# Manual Supplement

Manual Title:	Y8100	Supplement Issue:	1
Part Number:	534271	Issue Date:	11/95
Print Date:	February 1980	Page Count	3
Revision/Date:	2, 11/94

This supplement contains information necessary to ensure the accuracy of the above manual.

Figure A.

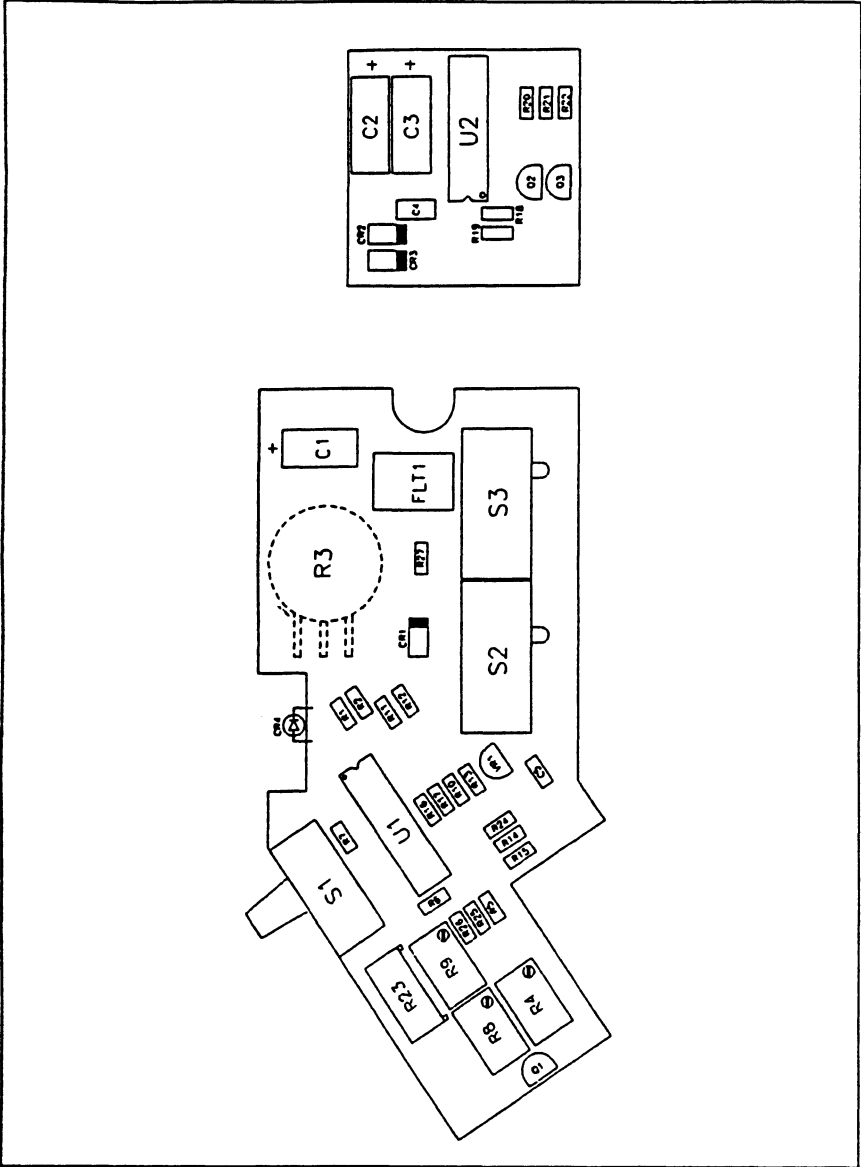
On pages 5-2 and 5-3, Table 5-1, make the following changes:

**ADD:** FLT1/EMI/RFI FILTER/1

**ADD:** H10/WASHER,.130 X.250 X .032/1

**CHANGE:** R25/RES,MF, 1K, +-1%, 0.125w, 100PPM/168229/1  
**TO:** R25,27/RES,MF, 1K, +-1%, 0.125w, 100PPM/168229/2

**ADD:** SB1/SHEILD BEAD/1

On page 5-4, replace Figure 5-1 as shown in Figure A.

Figure B.

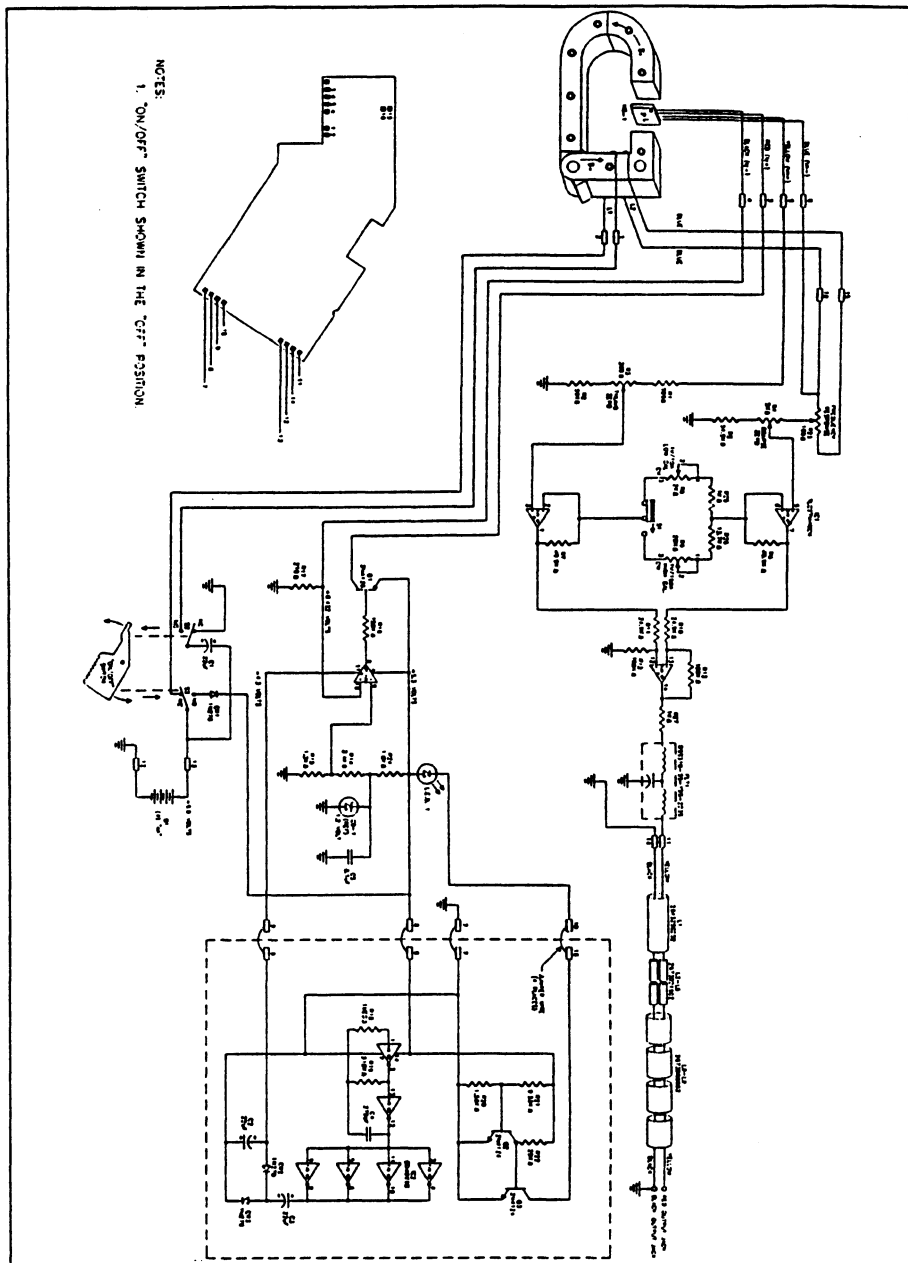
On pages 6-2 and 6-3, replace Figure 6-1 as shown in Figure B.
